Proposed design changes following consultation:

WAIMAKARIRI ROAD

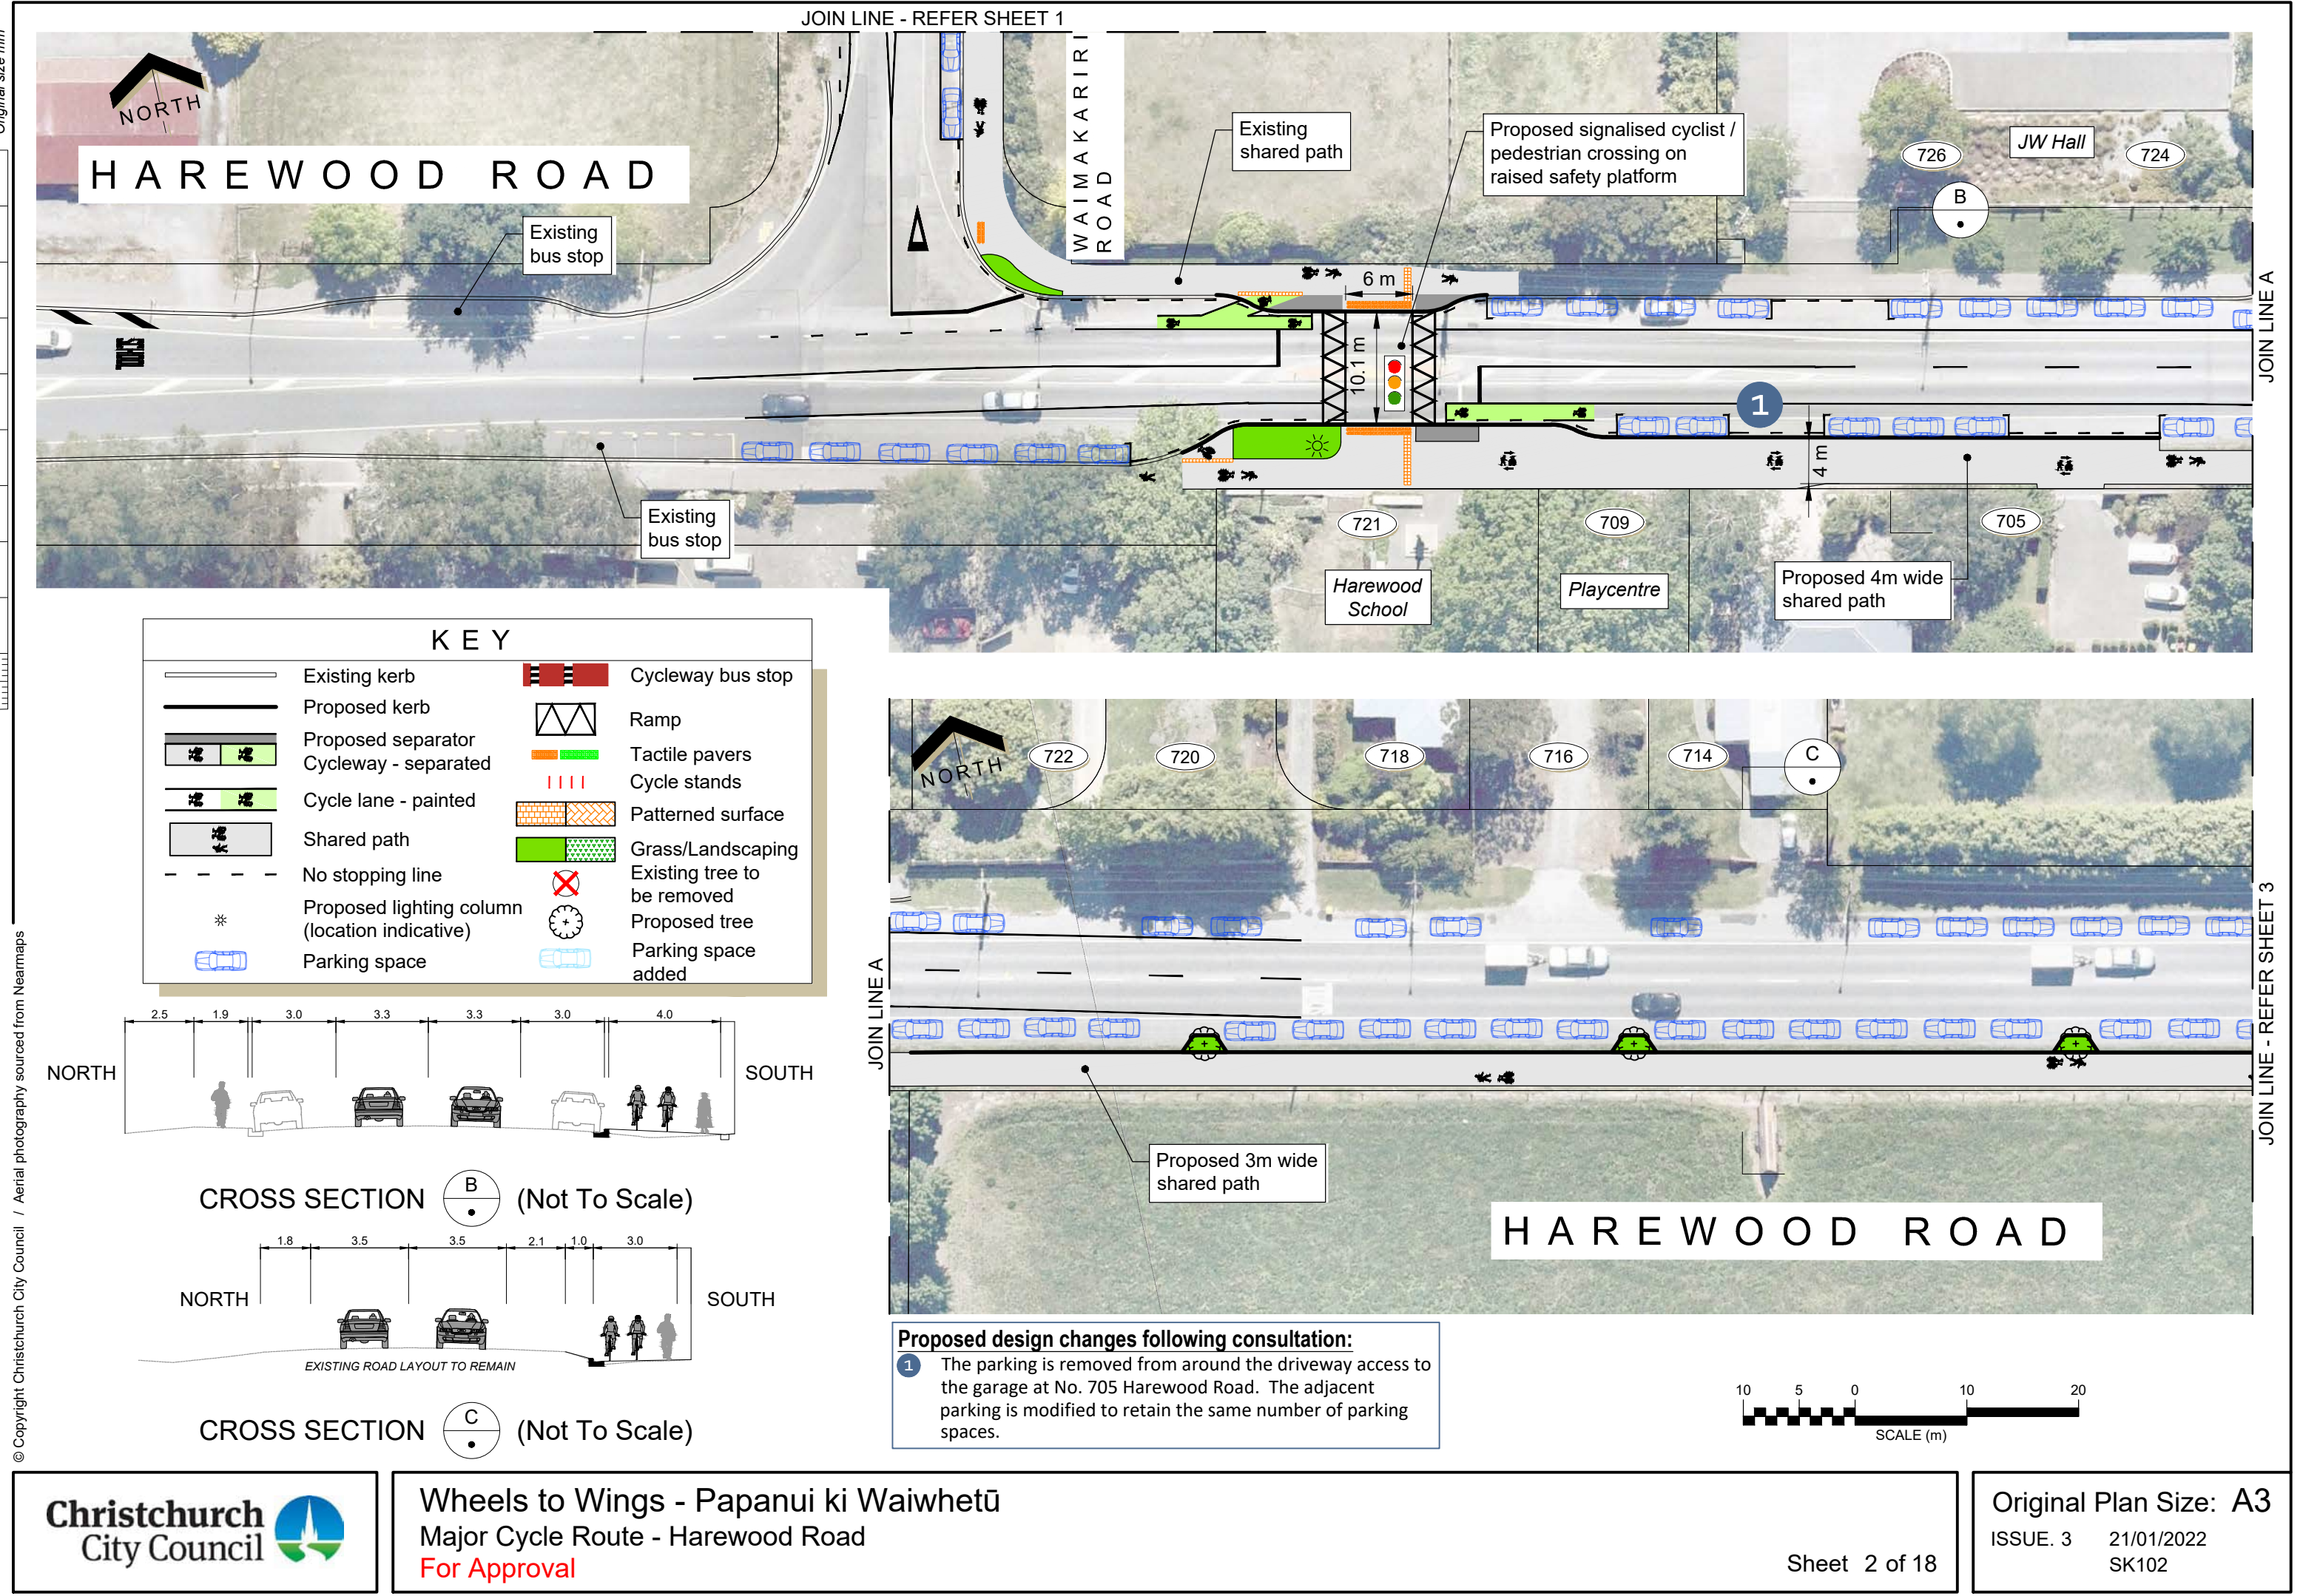
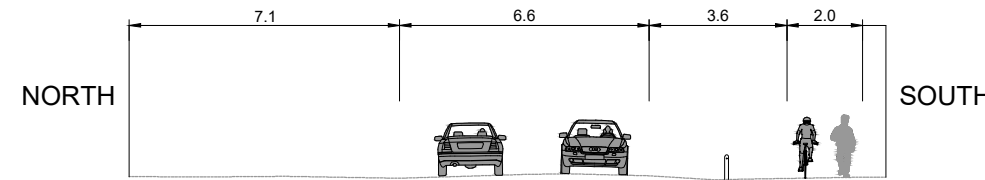
- 1 The proposed post and cable fence is replaced with a row of timber bollards.
- 2 An access onto the shared path for on-road southbound cyclists is added.

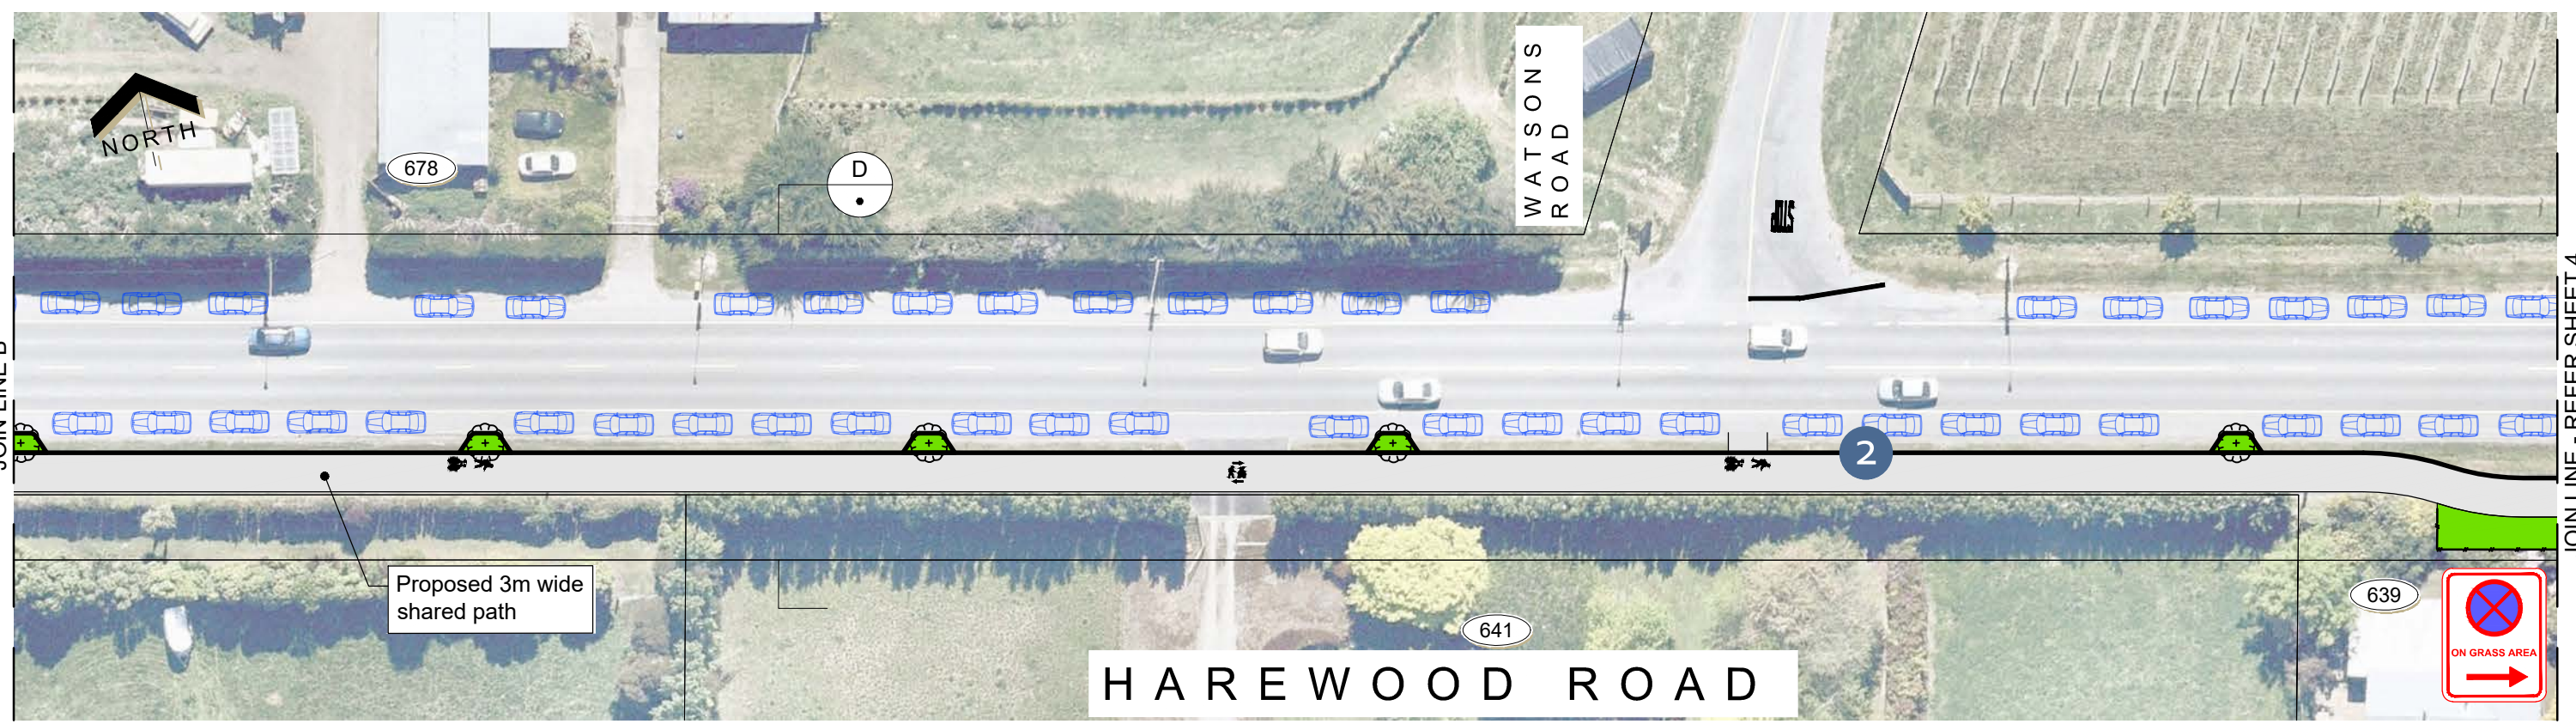
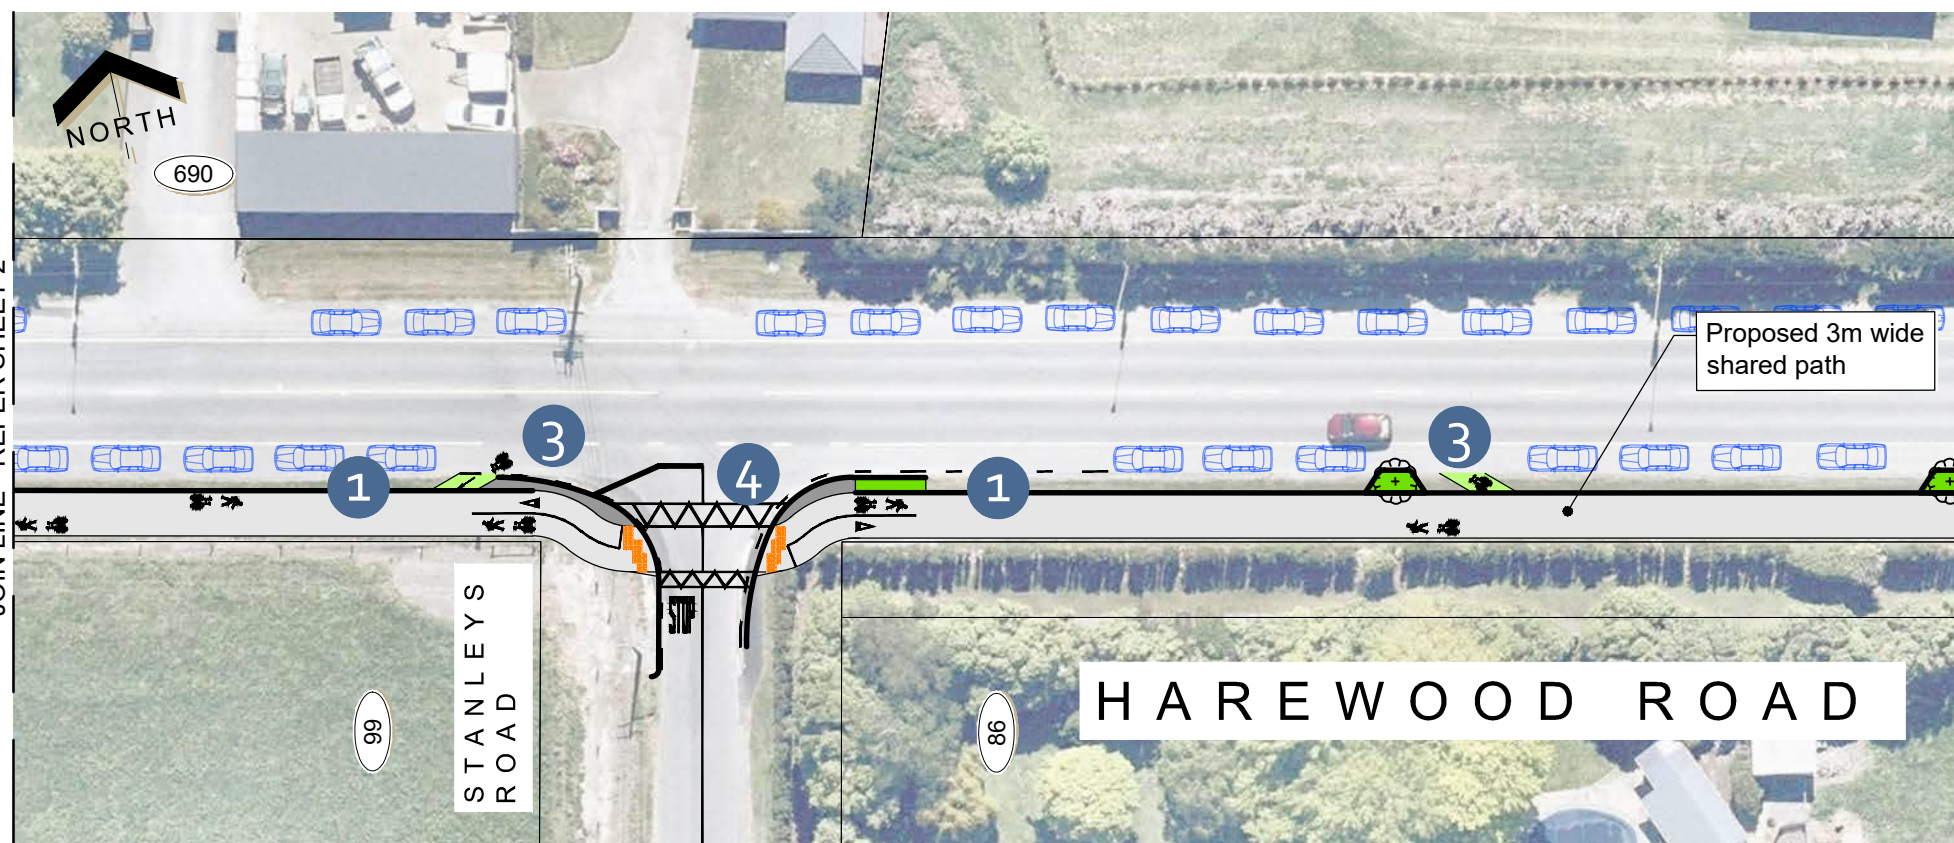
- Proposed design changes following consultation:**
- 1 The two proposed trees at the Stanleys Road intersection are removed from the design.
 - 2 The proposed tree opposite Watsons Road is removed from the design.
 - 3 Ramps are provided on and off Harewood Road so westbound cyclists can take a direct route through the intersection.
 - 4 The shared path crossing at Stanleys Road is set back to allow path users to cross behind a stopped car.

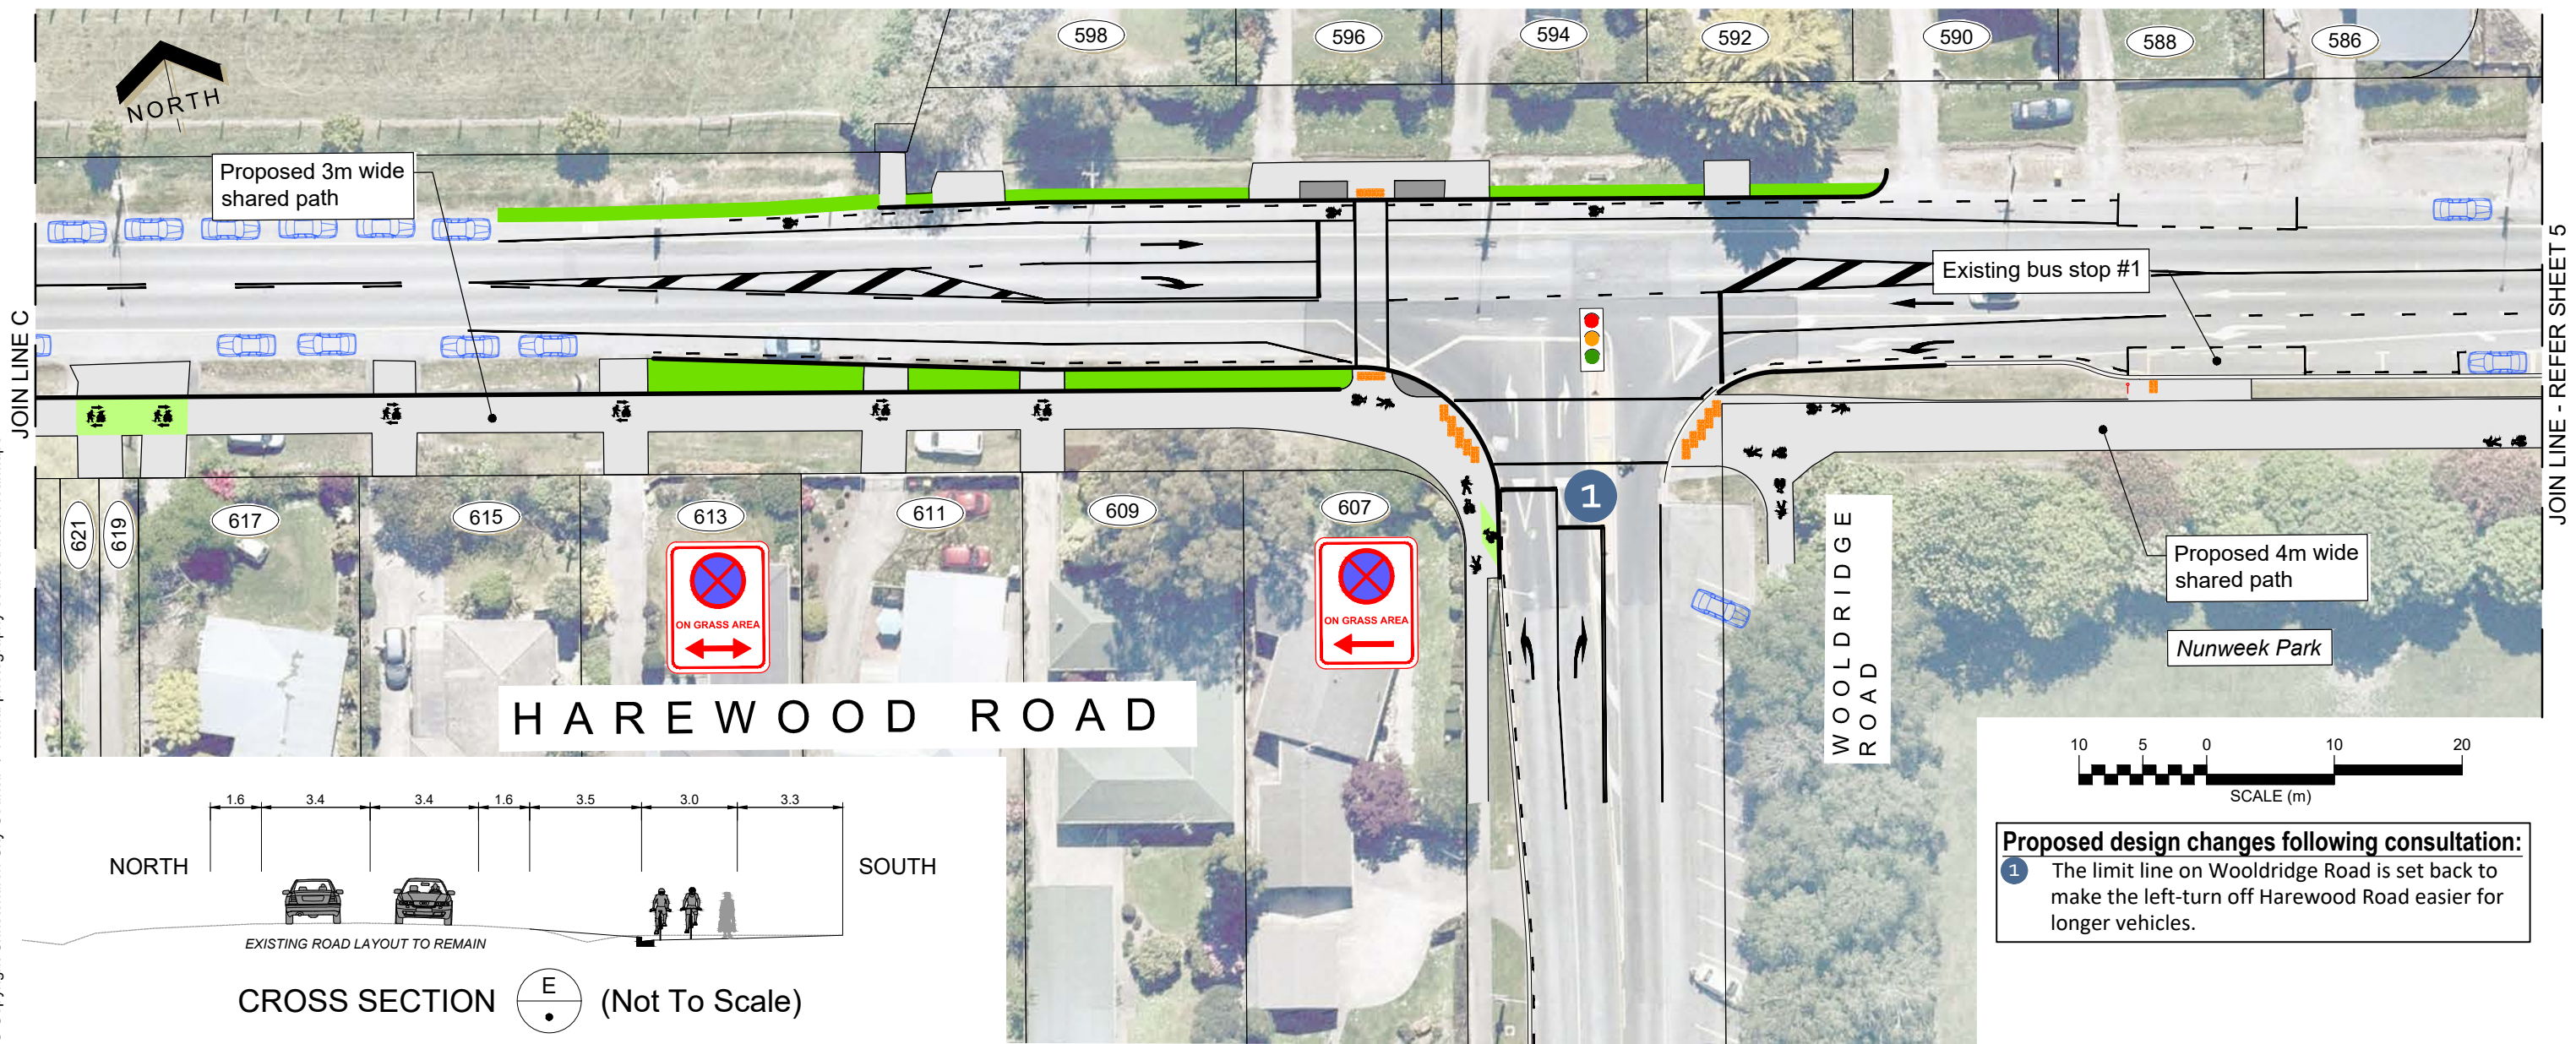
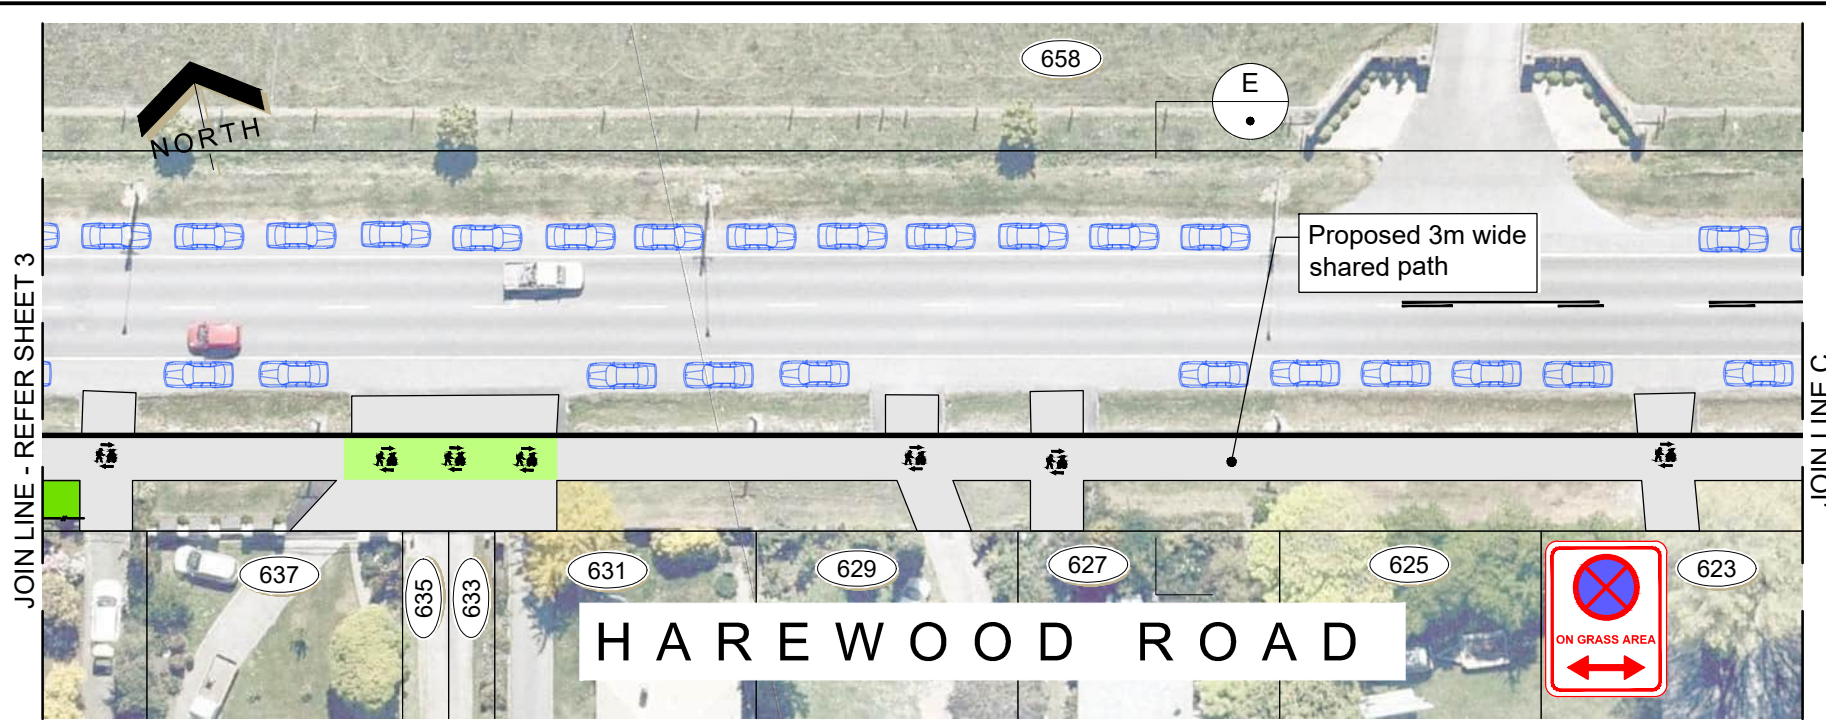
1 The limit line on Wooldridge Road is set back to make the left-turn off Harewood Road easier for longer vehicles.
